## TECHNICAL BULLETIN

GEN - 031E

Change of 3-point changeover switch

Size of switch mounting hole

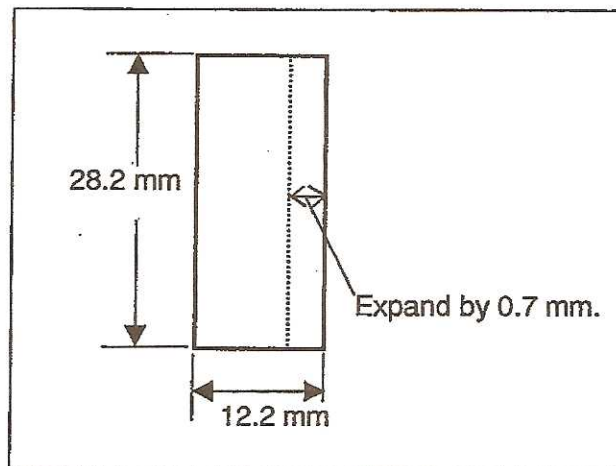
Name	Part No.	
	Before the change	After the change
3-point changeover switch 	96 559	983 43 006

There is a slight difference in size between the switches before and after the change. When mounting a changed switch to the presses in the field, process the mounting hole on the panel, as shown in the illustration below.

(Note) Wiring for switch terminals is not changed even after the switch is changed.
